STATE OF MICHIGAN
DEPARTMENT OF
ENVIRONMENT, GREAT LAKES, AND ENERGY
LANSING

SUBJECT: Michigan Department of Environment, Great Lakes, and Energy (EGLE) comments on the Area 5 Supplemental Remedial Investigation (SRI) Report, Revision 2 (Report), dated January 16, 2023, Operable Unit 5 (OU5), Allied Paper Inc./Portage Creek/Kalamazoo River Superfund Site (Site).

Allied Paper Inc./Portage Creek/Kalamazoo River Superfund Site
Area 5 Supplemental Remedial Investigation Report, Revision 2
OU5 – Kalamazoo River
January 2023

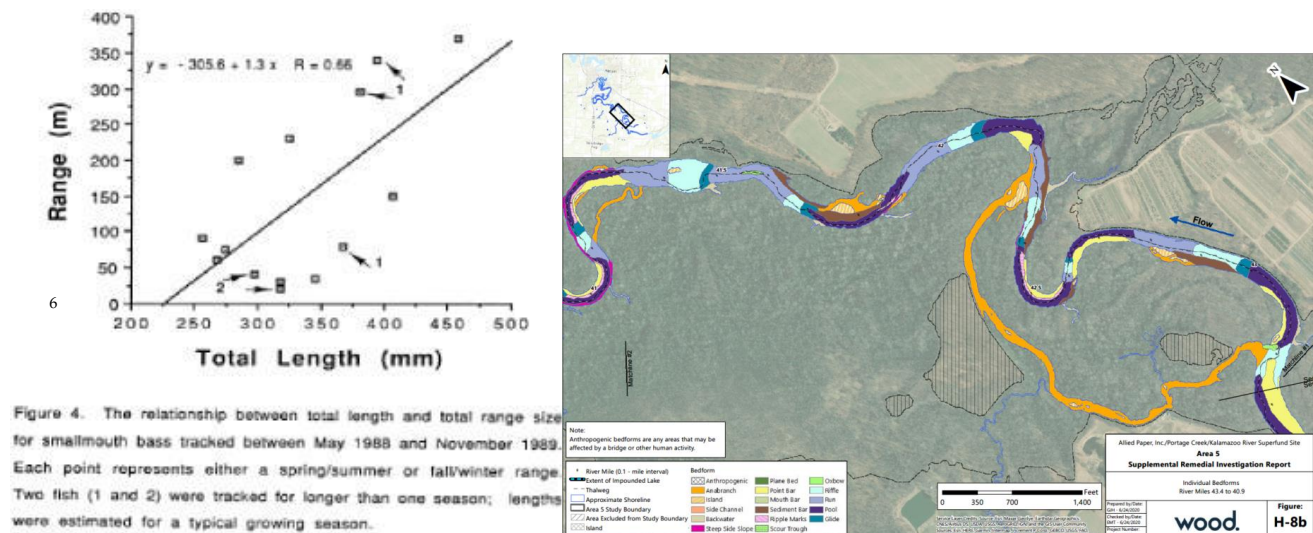
An example of the bedform mapping that was completed for Area 5 and is presented in the SRI Report (and detailed in Appendix H) is inserted above. The example figure provided shows key stream features (bedforms) of interest (e.g., riffles, pools, etc.) over a portion of Section 2. The bedform mapping that was completed for Area 5 shows that the bedform geometries and the distance from pool-to-pool and riffle-to-riffle are variable, but pool-pool and riffle-riffle sequences generally repeat every 300 meters (0.2 miles) to 500 meters (0.3 miles) in the Channelized Flow Reach. Figures in Appendix H suggest that there are a total of nine riffle-riffle sequences over 3.3 miles in Section 2 and ten riffle-riffle sequences over 2.75 miles in Section 3.

Sediment SWACs for total PCBs in the SRI Report are calculated for each Section by sample interval, and Sections range from 1.35 miles to 3.3 miles in length. Based on the observed movements of SMB in riverine systems similar to the Kalamazoo River and the site-specific geomorphology of Area 5, the exposure area that is represented by the calculated SWAC and used for comparison to the sediment CUL of 0.33 mg/kg for total PCBs in the SRI Report is likely significantly larger than a SMB “home range”. As a result, the general approach for developing SWACs in the SRI Report, which is based on large-scale geomorphology, may not be sufficient to identify sources or reduce receptor exposure. Sediment SWAC calculations should be developed over a smaller distance (area) that more closely replicates a potential exposure for the species of interest (SMB), which is likely on the order of a few hundred meters. Those results should be presented alongside the sediment SWACs for total PCBs that were developed for each Section based on large-scale geomorphology. Revise the document accordingly.

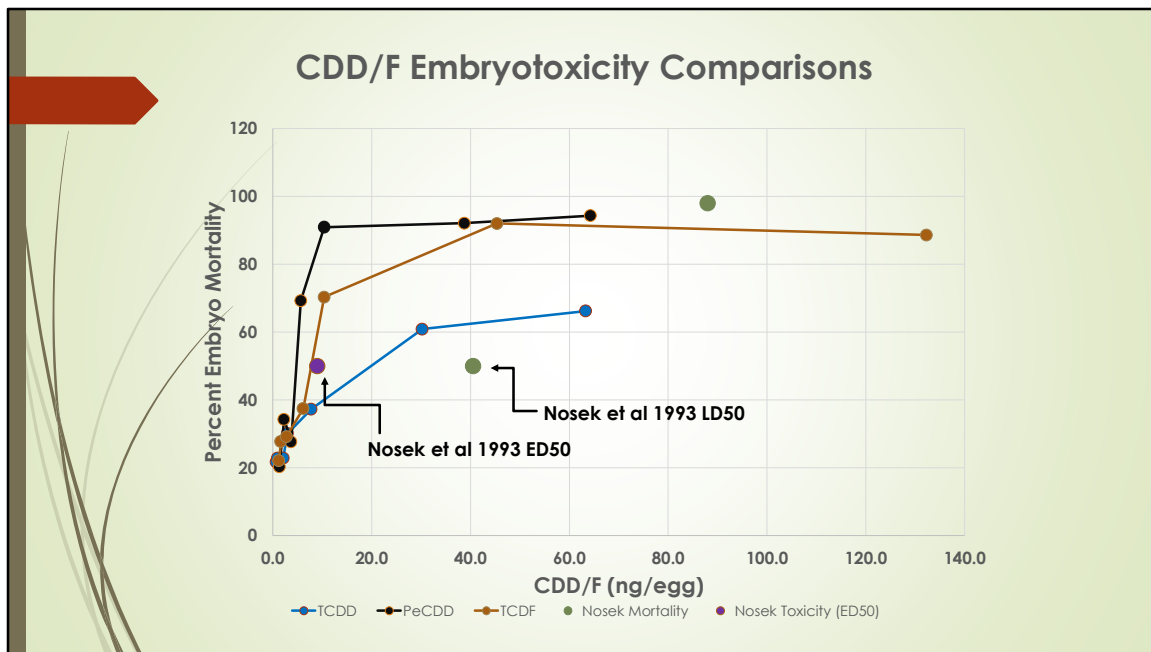
1. This chart is an overall summary of the analysis that compares RBCs calculated by Wood/GP without consideration of bioaccumulation (checkered bars) to revised RBCs calculated by CDMS/MDEQ taking into account impacts of bioaccumulation on TRV estimates (solid bars). The data and calculations are provided in the accompanying Excel file titled: "Revised_Area4_Floodplain_RBC_Summary_060418".

2. The yellow squares are the geometric means across the RBC estimates (NOAEL and LOAEL based (ecological risk). Geometric means were not calculated for the HH RBCs.

3. The (w) following receptors on the x-axis indicate that values in the chart are from Wood/GP.
4. Each bar for ecological receptors represents NOAEL and LOAEL estimates from a single TRV source. For example, the bottom of the solid **ocher bar** for the woodcock is the NOAEL and the upper end is the LOAEL derived from TRVs from Nosek et al. as developed by CDMS/MDEQ using bioaccumulation. The checkered **ocher bar** for woodcock(w) is similar, but is developed from Nosek et al. by Wood/GP without consideration of bioaccumulation.

5. For mammals (shrew and fox) the **ocher bars** represent TRVs from Murray et al., and the **dark blue** bars represent TRVs from Sparschu et al. For the fox, the

dietary assumptions of both soil to bird (fox1) and insect to bird (fox2) are presented. Again, solid bars represent TRVs adjusted for bioaccumulation.

6. The solid horizontal lines represent 420 ppt, the RBC estimate based on a cancer risk for recreational visitors of 1 in 100,000, and 840 ppt, a midpoint of values based on cancer and non-cancer endpoints. Calculations of RBC used spreadsheets provided by Wood/GP with the only modification being revised TRVs (see following slides).

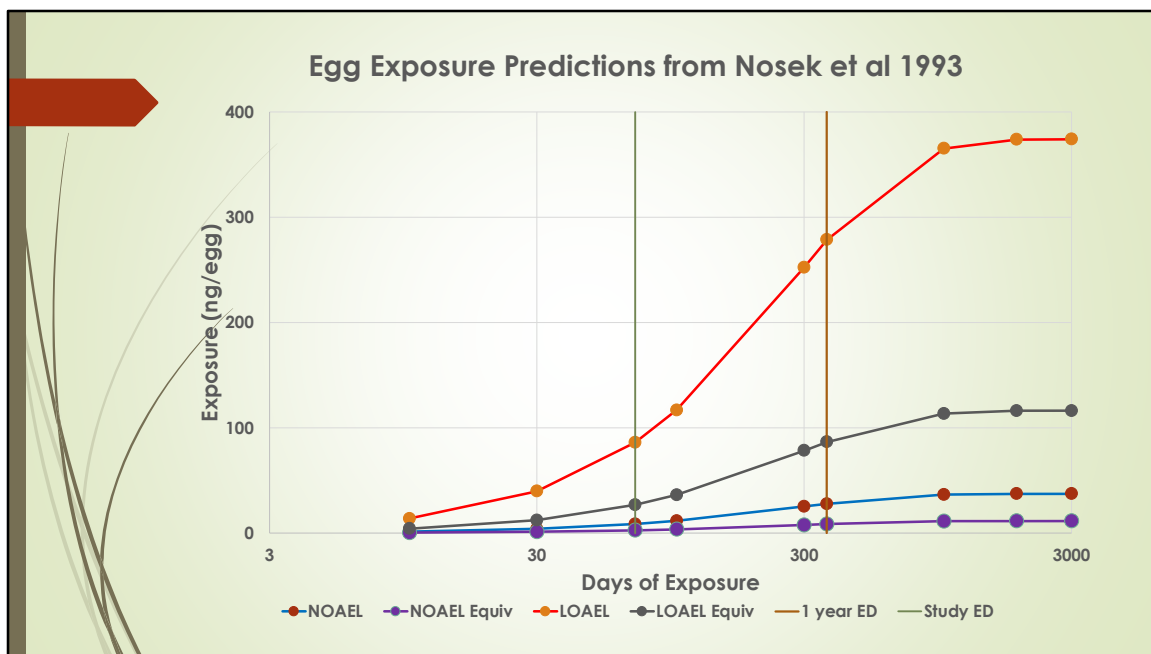
1. This figure uses literature data to demonstrate the steep dose response curve for egg injection studies. The data and calculations are provided in the accompanying Excel file titled: "Embryotoxicity_Cohen-Barnhouse_060418".

2. For PeCDD, control to 100% mortality occurs over a range of 0 to 10 ng/egg.
3. An LD₂₀ (a non-conservative endpoint to use to quantify a lethality LOAEL) would be in the range of 2 ng/egg (control mortality was about 20 percent so that an increase of 20% would occur at about 3 ng/egg).

4. The egg injection study results compare well with results of hen dosing reported by Nosek et al. The ED₅₀ for hen toxicity occurs at a slightly higher dose than does embryo mortality. Further, any LD₅₀ for embryo mortality is consistent with almost complete mortality in egg injection studies. Exposure rate for hens that result in a dose to eggs in the range of a few ng/egg are likely to result in significant impacts.

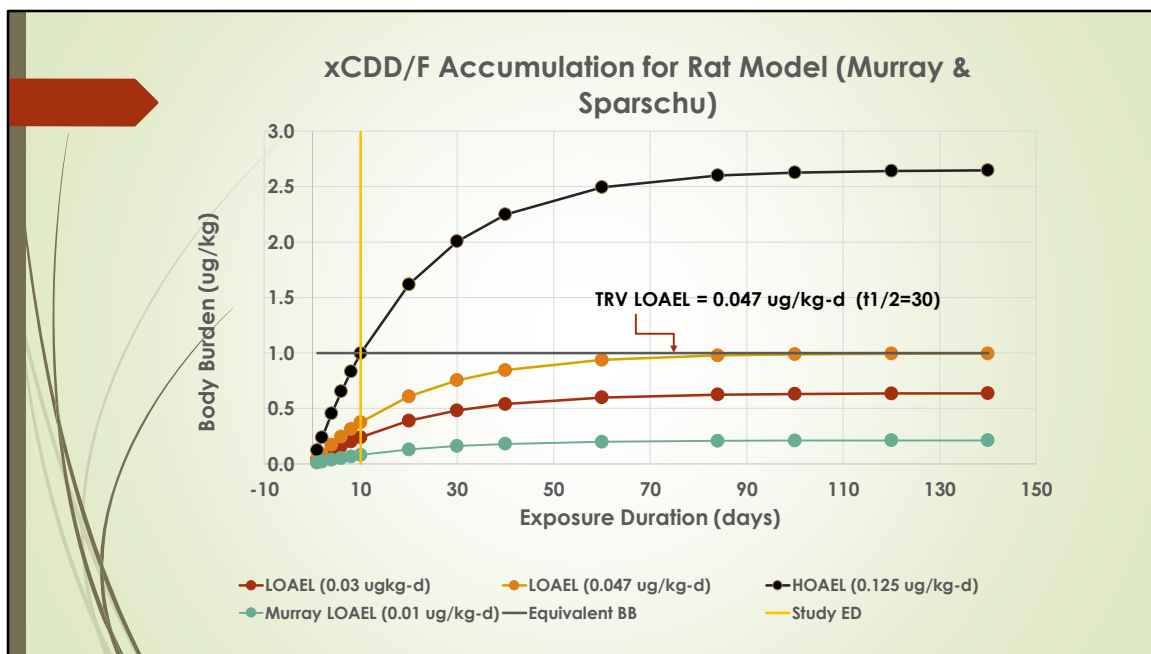
1. This chart plots predicted body burdens for rats at exposure rates used in the Murray et al. and Sparschu et al. studies. Data and calculations for all of the analysis are provided in the accompanying Excel file titled: "xCDD_Accumulation_Rat_Predictions_060418".

2. Body burden is used as a surrogate for plasma concentrations since volume of distribution of xCDD in rats is not known.
3. Calculations assume a half-life for xCDD of 30 days. This assumption is reasonable for lower chlorinated congeners, but likely underestimates half-life for congeners with higher levels of chlorination.

4. Sparschu et al. reported impacts after 10 days of exposure of embryos at a dose rates of 0.125 ug/kg-d and higher. Toxicity was not observed at a dose rate of 0.03 ug/kg-d over the same time period. The short exposure duration does not allow for bioaccumulation and significantly underestimates body burden after longer exposure periods.

5. The Study ED line shows point in time where investigators ceased dosing.
6. Predicted body burden is much higher if exposure is assumed to continue for several half-lives. To recalculate a RBC based on body burden, an exposure rate was estimated that results in a body burden after 100 days of exposure that is similar to the body burden predicted at 10 days. This dose rate (0.047 ng/kg-d) is

recommended as a upper range estimate of LOAEL (i.e., a dose rate that is likely to result in significant toxicity).

7. Similarly, a dose rate of 0.011ug/kg-d for a 100 day exposure duration predicts the same body burden as estimated for a 10 day exposure, which is essentially the same as the LOAEL estimated in the Murray et al. study.
8. Recommendations for mammalian TRVs are therefore: NOAEL = 0.001 ug/kg-d (Murray et al.); LOAEL = 0.01 ug/kg-d (Murray et al. and Sparschu et al.); LOAEL (upper range estimate) = 0.047 ug/kg-d (Sparschu et al.).
